CITY OF HUXLEY

A SESSION OF THE CITY OF HUXLEY'S PLANNING AND ZONING COMMISSION

HUXLEY, IOWA
KUM & GO
SITE PLAN REVIEW

SITE PLAN
HUXLEY MINI-STORAGE
508 E. FIRST AVENUE

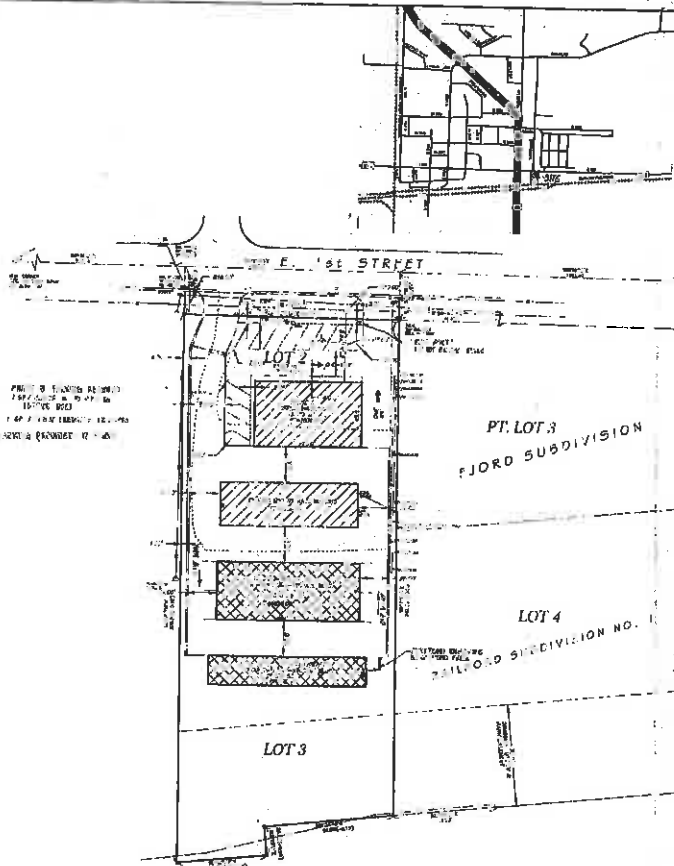
Attached is the approved site plan for the site from December 1999. Chris is essentially wanting to complete Phase 3 of the site plan. The proposed building would have a similar footprint to the north building shown on the site plan.

The paving of the drives around the mini-storage buildings as described in Phase 2 was never completed. Currently there is gravel around the buildings.

Phase 3 describes the construction of a second driveway entrance, parking spaces at the north end of the site, and the installation of a sanitary lift station and water service. The sewer and water services are not needed as the building is proposed to be used for storage with internal access and not to be used for an office/warehouse.

The discussion with Planning & Zoning will focus on providing some direction for the site plan. Is the site plan still valid? Do all of the phasing requirements of the site plan need to be followed, or just some of the phasing requirements? Which ones? Assuming the existing site plan is still valid, at what point are there enough changes that a new site plan needs to be submitted?

If a new site plan were submitted, what is the thought of obtaining a waiver for not paving and leaving the site gravel? What would be the stormwater management requirements?

There is an existing sidewalk to the west but no sidewalk to the east. Will a sidewalk be required?

0131 - HUXLEY, IOWA
I-35 & IA-210
GRADING PLAN

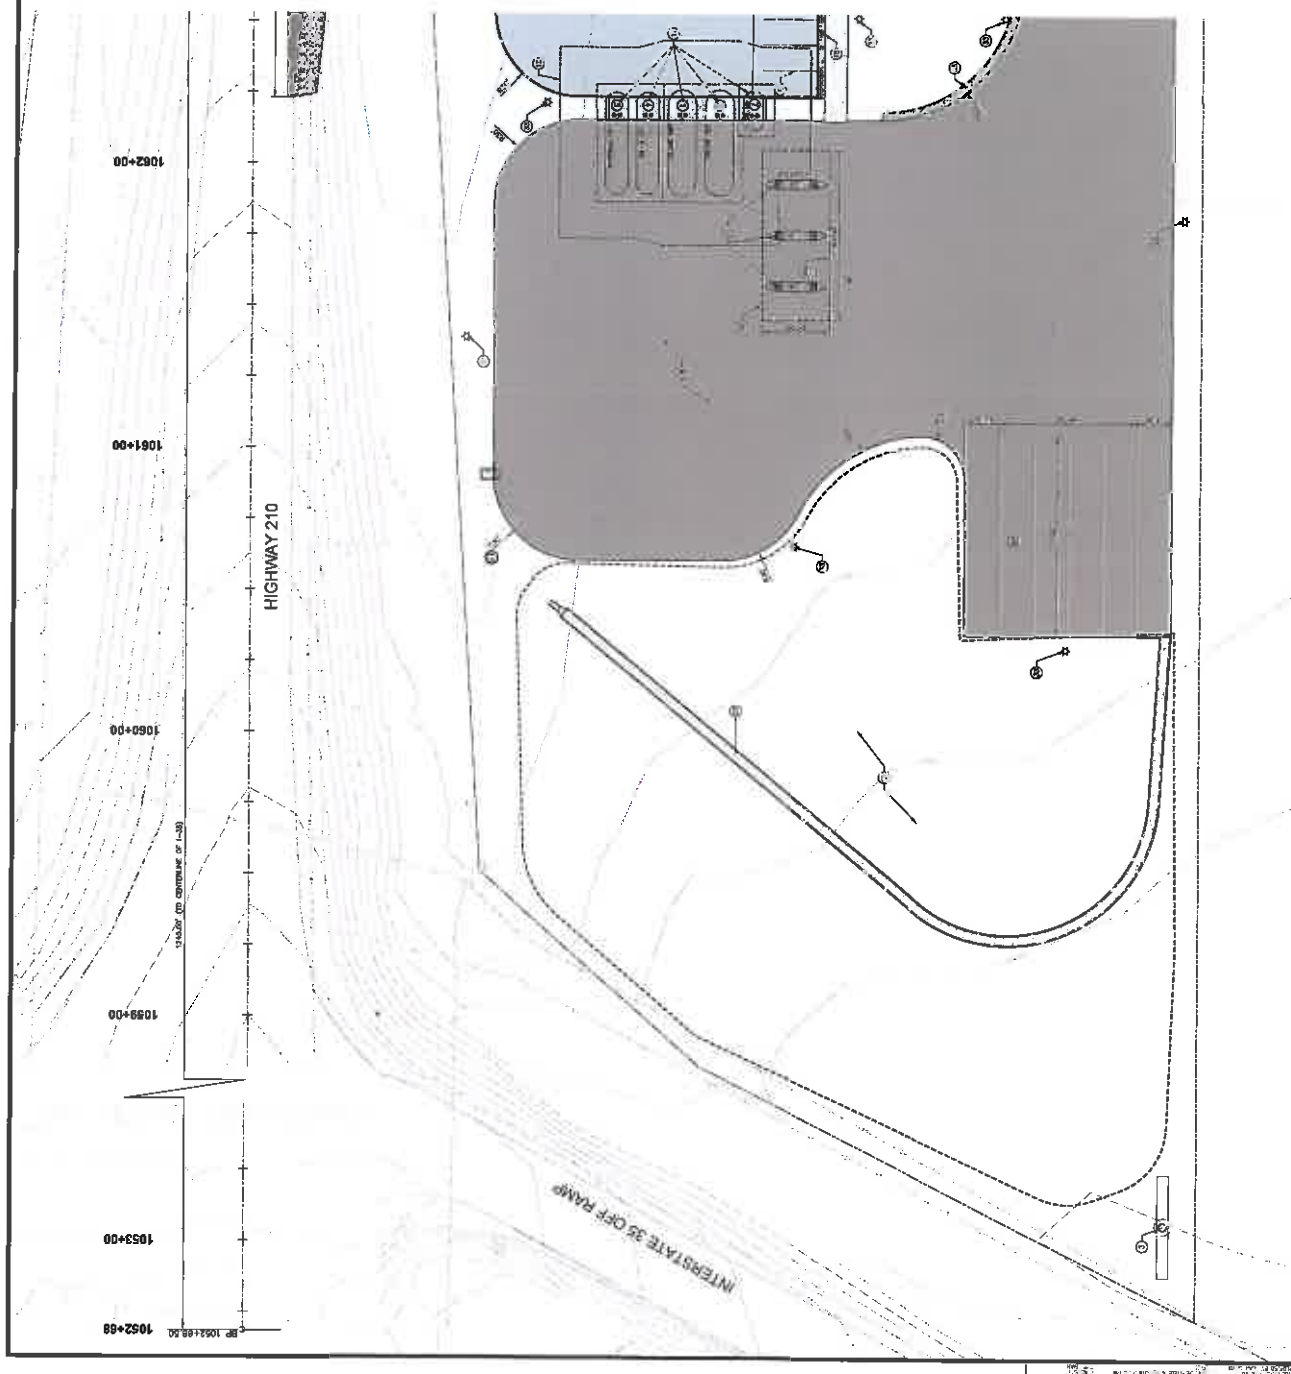
1. The detention basin berm needs to have a side slope of 4:1 or flatter in accordance with SUDAS Design Manual Section 2G-1.F.1.a. The slopes on Sheet Nos. C2.1 and C2.3 are labeled as being 3:1 (33.33%).
2. The overflow spillway on the north side of the detention basin needs to be dimensioned and spot elevations provided on Sheet No. C2.1.
